Office Action Summary

10/791,699

SCHAAP ET AL.

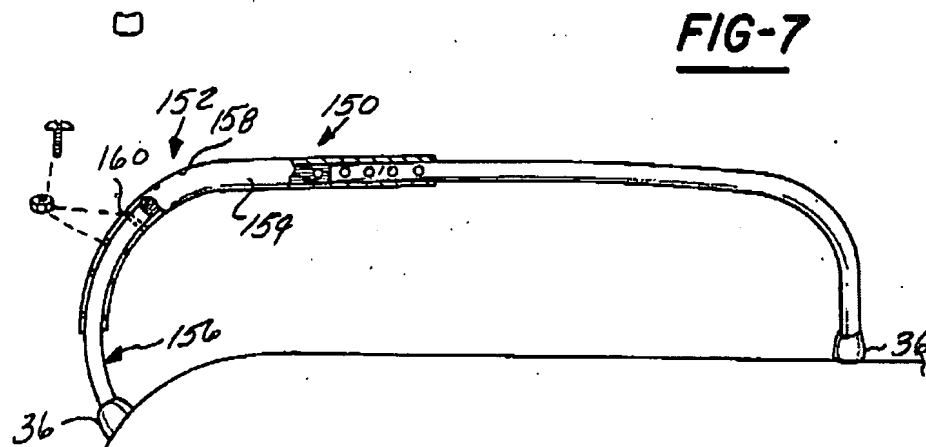
Re 11: Meyers, especially in Figs 1-2 11-12, and 14-15, along with the EAST text searches available in file wrapper copied below from column 5, teach a wheelchair having a front wheel support comprising a curved tube 13 and a curved part 14 with a 1st portion having identical curvature as the curved tube, and the cross section of the curved part 1st portion allows it to fit inside the curved tube, and a second portion of the curved part has a wheel sear (at 12) such that the curved part 1st portion can be telescopically shifted inside the curved tube providing increased or decreased overlap.

Referring additionally to FIGS. 4 through 7, the 55 shower-commode chair 10 has a tubular steel frame 11 supported on wheels 12. The shower-commode chair has four tubular legs 13 with an inner tubular member 14 telescopically received in the bottom ends on which the wheels 12 are mounted. Height adjustment holes 15 60 extend between the tubular members 13 and 14 and are selectively engaged by a locking push button or pin 15A in a conventional manner such that height adjustments can be obtained. Because the leg height of the chair is adjustable, it is possible to accommodate the chair to fit 65 various toilet bowl heights, bathtub heights, and the height of other objects, such as a bed or wheelchair, to and from which the disabled user is transferred.

Re 4: There is a load path provided between the curved part and curved tube (at the overlap).

Re 5: The securing arrangement is the locking push button or pin 15A.

Re 7: The 1st portion comprises a section that can be expanded to form a tight fit with respect to the **curved tube**. Note that "can be" only requires that it be physically possible to do this.

Re 8: The 1st portion comprises a section that can be expanded by means of a screw or ring-shaped element. Again, note that "can be" only requires that it be physically possible to do this.

Re 10: There is at least one front wheel support (Fig 1-2).
